Subject: U.S. EPR Design Certification Application RAI No. 133 (1456), FSARCh. 19

Request for Additional Information No. 133

U. S. EPR Standard Design Certification

Docket No. 52-020

Figure 19-240-1—U.S. EPR PRA CDES Link Trees
Sheet 1 of 29

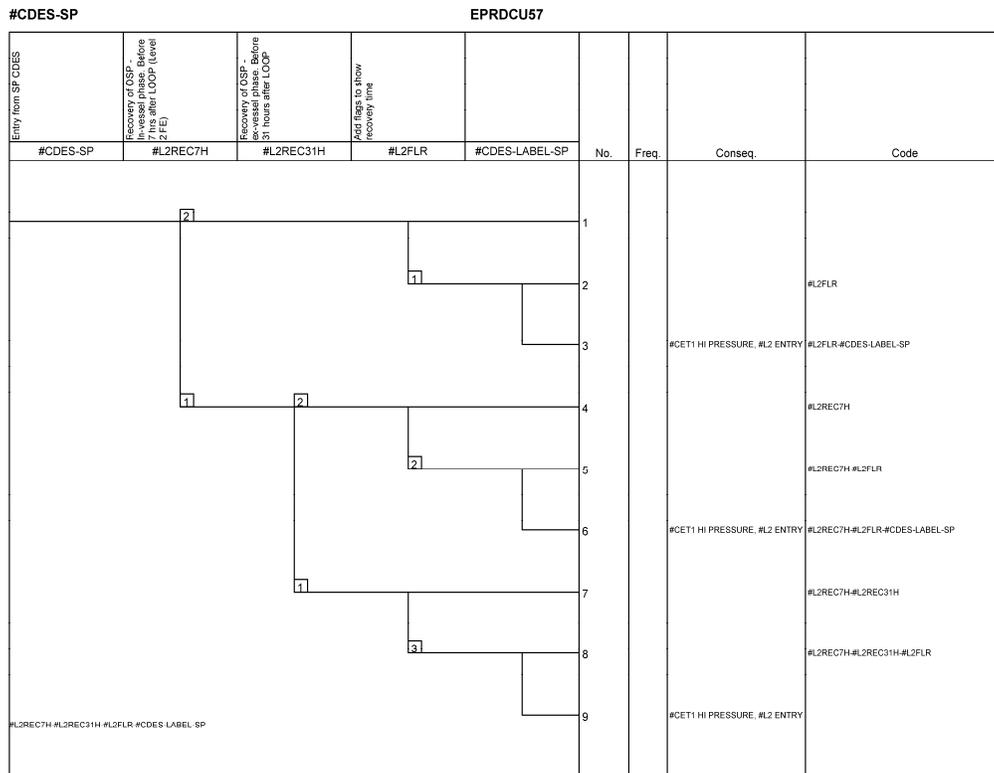
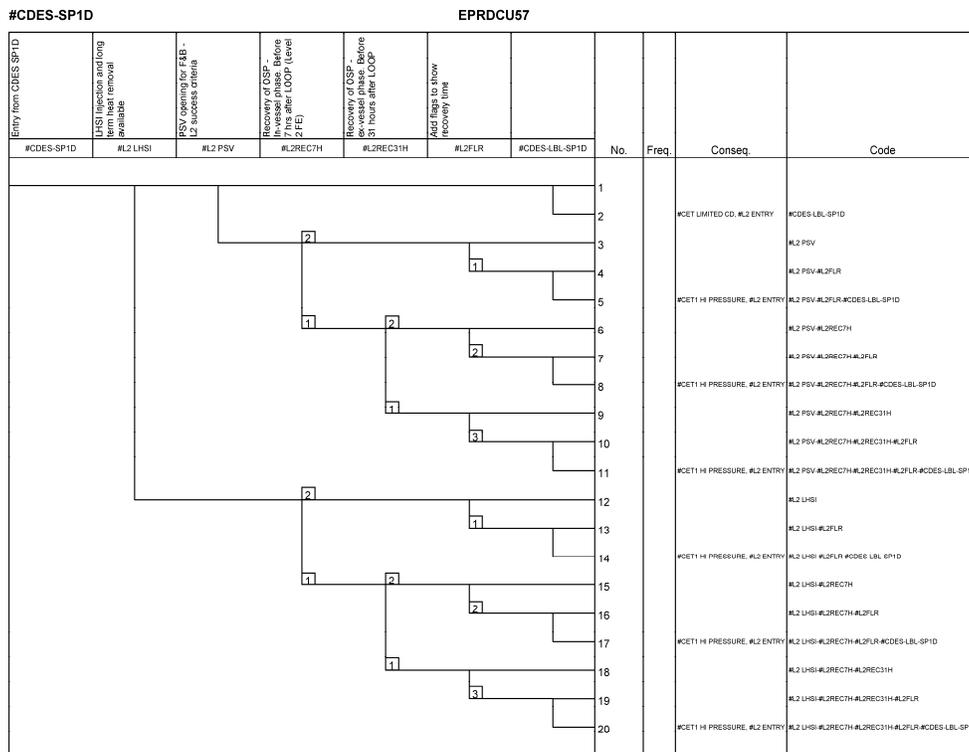
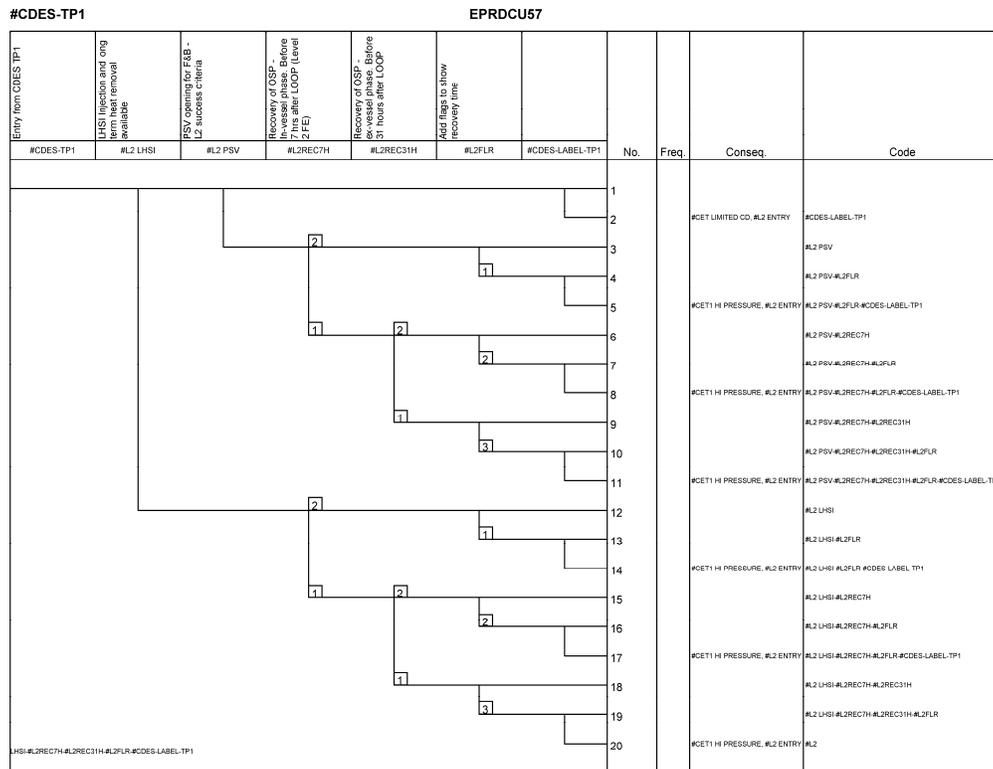
3. The response to Question 19-79e states that system-related top events in the containment event trees are used to model the status of containment isolation, safety injection, severe accident heat removal, and other systems. But FSAR Section 19.1.4.2.1.3 states that the CDES are not, however, directly transferred to Level 2 CETs. Rather, each individual end state is transferred through an intermediate event tree, referred to as CDES link event tree, prior to transfer to a Level 2 CET. Please provide the details of these link event trees, including diagrams, tables of grouping and quantifications, how they are applied to each of the CDESs and how they are linked to the Level 2 CETs that are shown in FSAR Appendix 19C.

Link trees used for CDES: AT, ATI, IS, LL, SG, SG3, SL, SLD, SS, SSD, TR and TRD only add a flag to the sequence before sending it to the appropriate CET. The correspondence between CDES and CETs is shown in U.S. EPR FSAR Tier 2, Table 19.1-16.

Table 19-240-1 describes the function of these more complex link trees. The link trees are shown in Figure 19-240-1.

Figure 19-241-1—CRGA Details

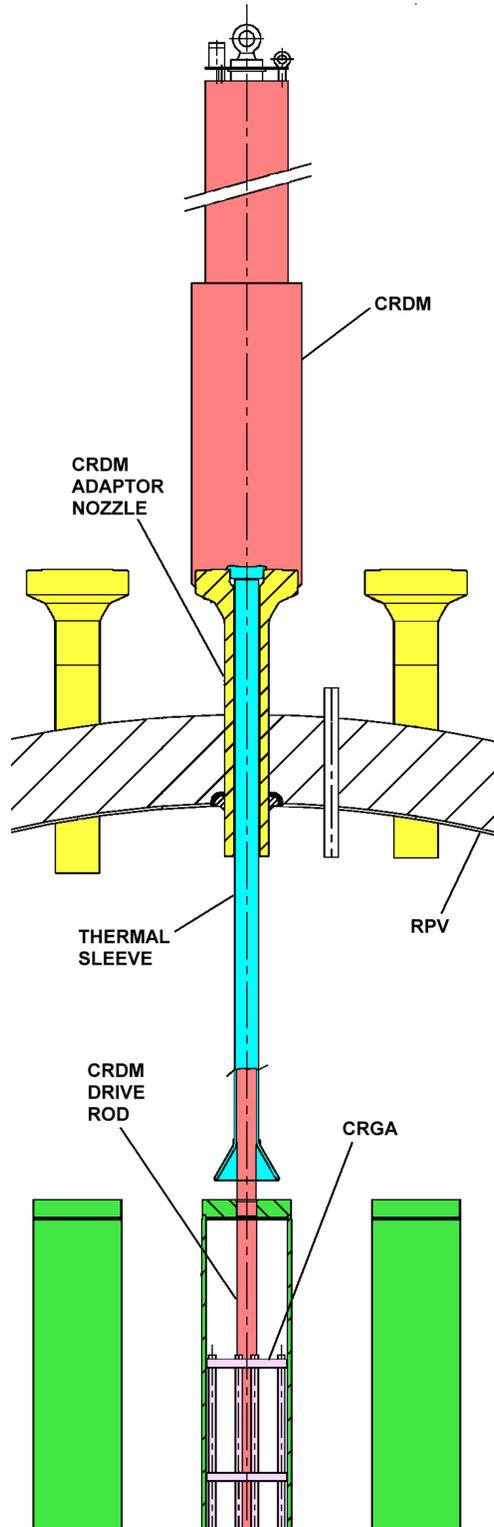
Please provide the inner diameter of the control rod guide assembly (CRGA) in the location where it penetrates the RPV upper head.

The CRGA does not penetrate the reactor pressure vessel (RPV) upper head (See Figure 19-241-1). The control rod drive mechanism (CRDM) adaptor nozzle penetrates the RPV upper head. A thermal sleeve is installed inside the CRDM adaptor nozzle and the CRDM drive rod is inserted through the thermal sleeve into the CRGA.

Figure 19-246-1—MAAP4 vs. S-RELAP5 Core Temperature (Best Estimate)

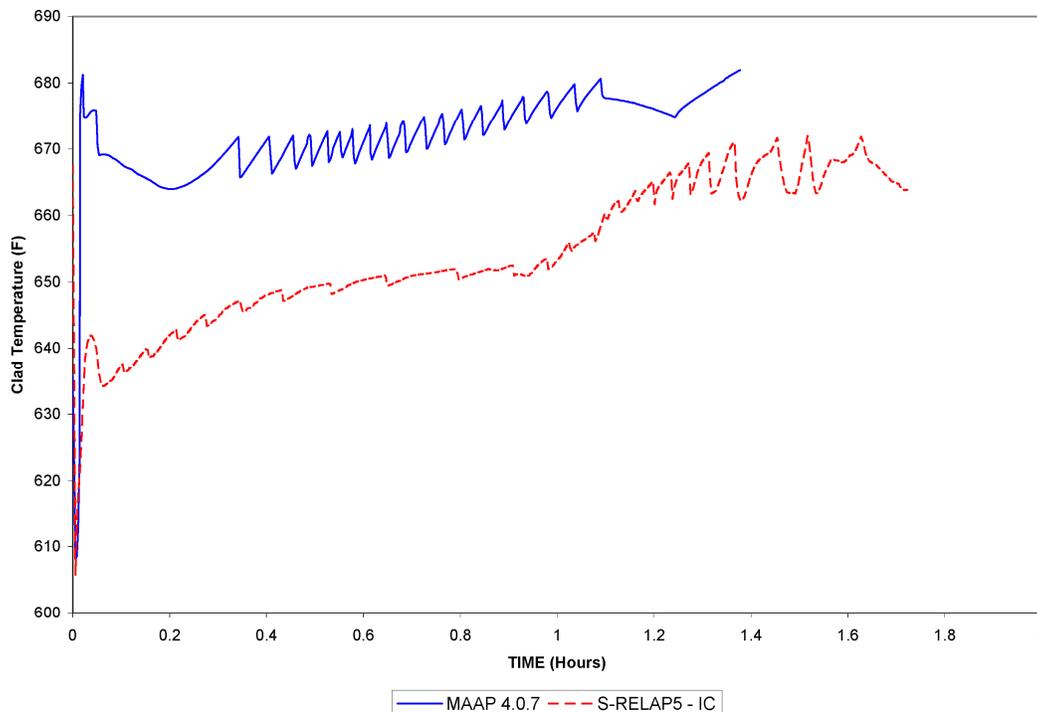
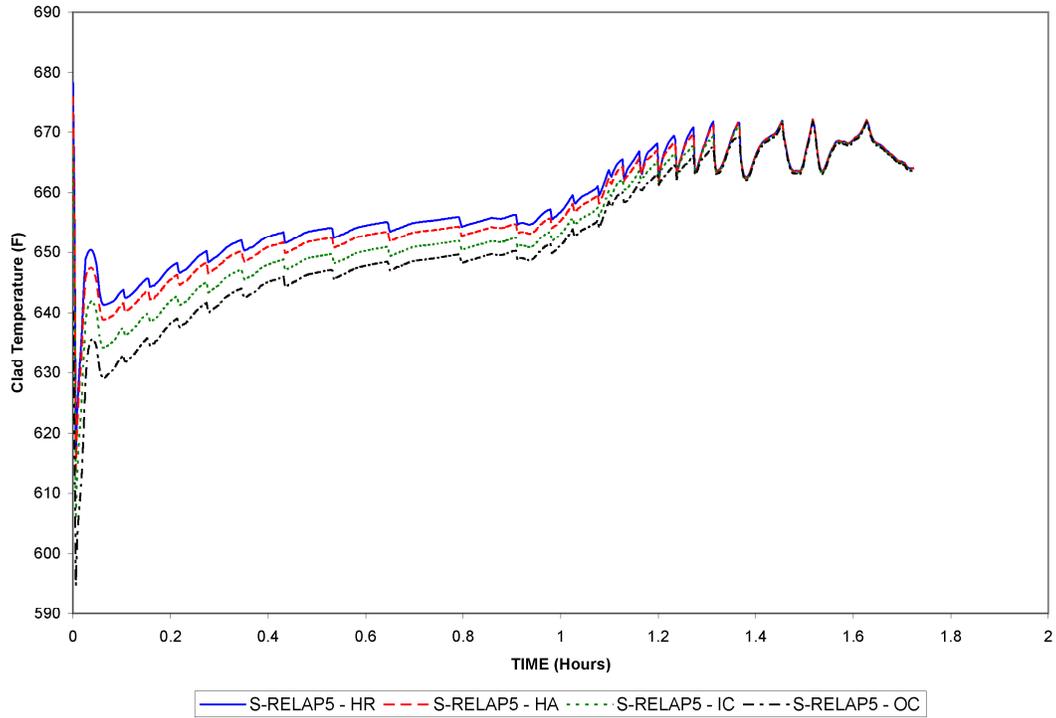
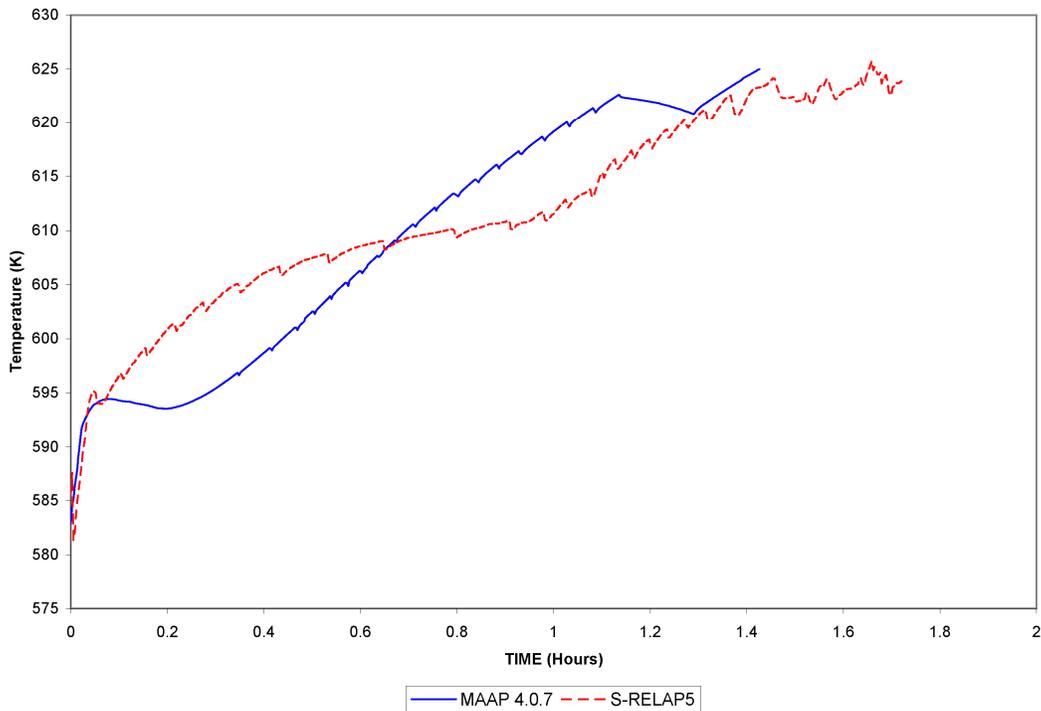
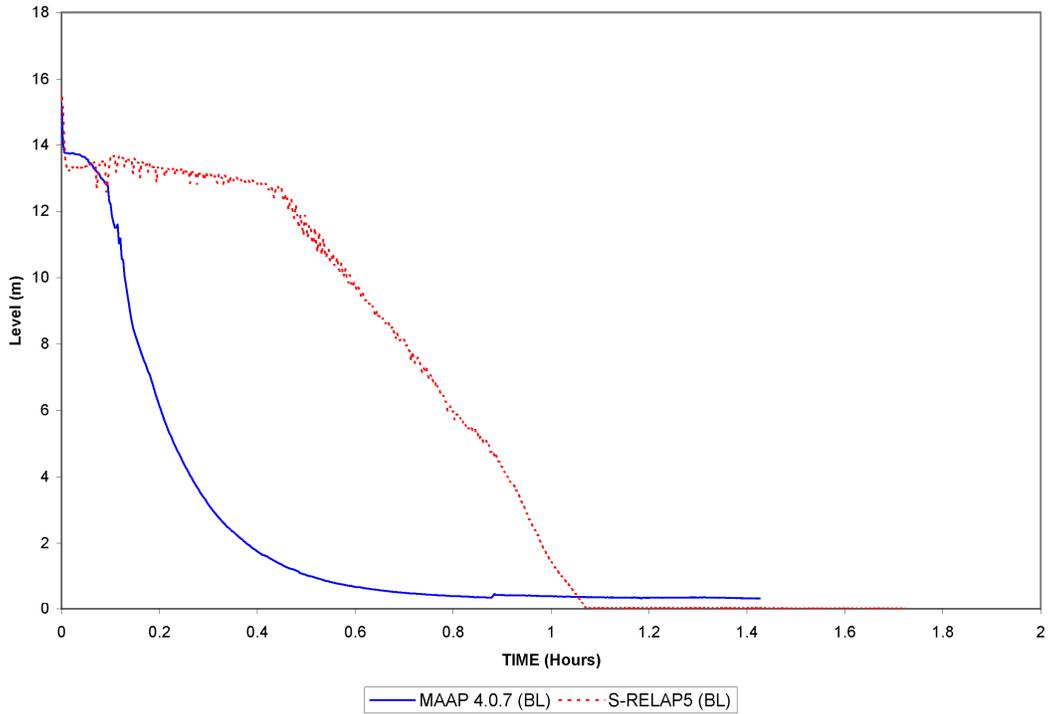
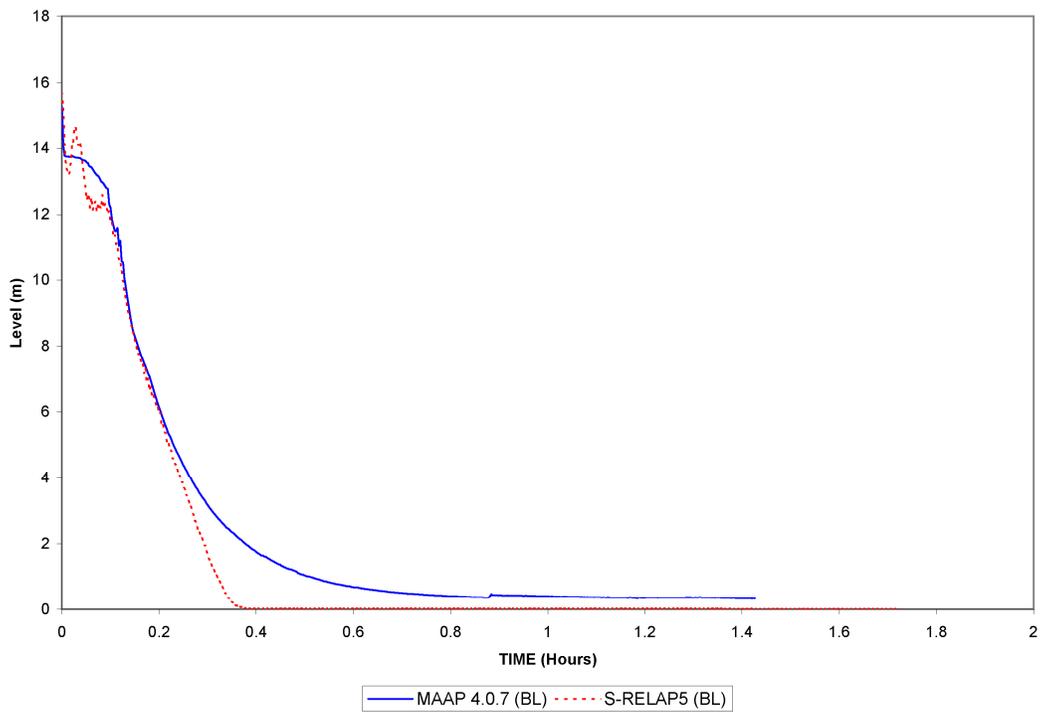
Please provide detailed results of the MAAP 4.0.7 and S-RELAP5 calculations to determine Level 1 success criteria. Also include the results of benchmarking MAAP 4.0.7 against S-RELAP5 and explain how the benchmarking was performed. As part of your discussion:

1. Please provide results of all of the analytical comparisons made, and include any cases that provide a direct core heatup comparison.
2. Please explain why phenomena associated with these events are expected to extend to the remaining events of interest, such as steam generator tube rupture, steam line breaks (inside or outside containment), and loss of off site power.

Figure 19-246-1 presents the maximum core temperature from MAAP4 and compares that to a similarly modeled S-RELAP5 core region. Because the S-RELAP5 core region model is finer than MAAP4, the S-RELAP5 result is not a maximum value for the calculation; instead, as shown in Figure 19-246-2, the maximum core temperature is given from a modeled high power rod within a high power or “hot” assembly. Figure 19-246-3, average core water temperature, illustrates a difference between MAAP4 and S-RELAP5: primary-to-secondary heat transfer. The lower temperature in the MAAP4 calculation suggests that more heat is leaving the primary than predicted in the S-RELAP5 calculation. This also helps explain the difference between fuel temperatures in Figure 19-246-2. Specifically, heat transfer from the fuel to the coolant is obviously lower in the MAAP4 calculation, and is attributed to different heat transfer regimes predicted by the two codes. It does not have significant influence on the event simulation.

Figure 19-246-4 shows the steam generator liquid level. This provides the best evidence of the primary-to-secondary heat transfer difference. Both simulations show the impact of high and low primary-to-secondary heat transfer. MAAP4 shows an initial high primary-to-secondary heat

Agreement is improved between the codes. With the one RCP running for 20 minutes in the revised calculations, S-RELAP5 results do not show an equivalent primary-to-secondary heat transfer rate. In fact, the S-RELAP5 simulation exhibits more primary-to-secondary heat transfer than MAAP4 (e.g., lower early temperatures). Comparison of the liquid level in the steam generator is in better agreement as shown in Figure 19-246-5.
